College of Engineering
UF Training Reactor Facility

10 CFR 50.4, Written Communications
UFTR Operating License R-56, Docket 50-83

Subject: **UFTR Responses to Request for Additional Information (TAC NO. ME1586)**

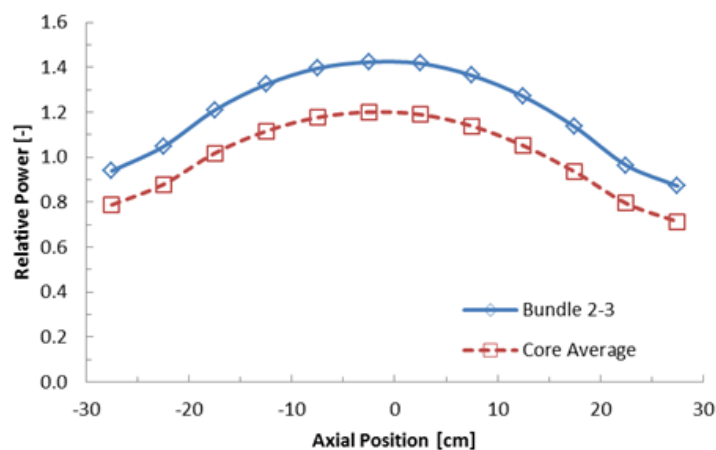
1. UFTR SAR, Chapter 4, "Reactor Description," describes the general purpose Monte Carlo N-Particle code (MCNP6) model used to determine the SLs for the UFTR. The NRC staff reviewed the analysis, and is not clear regarding the use of any additional uncertainties, peaking factors, or power shapes, to represent the power gradients which result in a conservative peak fuel temperature and minimum departure from nucleate boiling ratio (DNBR).

NUREG-1537, Part 2, Section 4.6, "Thermal-Hydraulic Design," states, in part, that the SLs should include conservative consideration of the effects of uncertainties. Provide the peaking factors, or power shapes, used in the neutronics analysis, as well as any uncertainties, or justify why no additional information is needed.

Power distributions were calculated axially per-bundle and radially across the core. Radial power distributions (F_Q) and axial power distributions (F_{dH}) were calculated as;
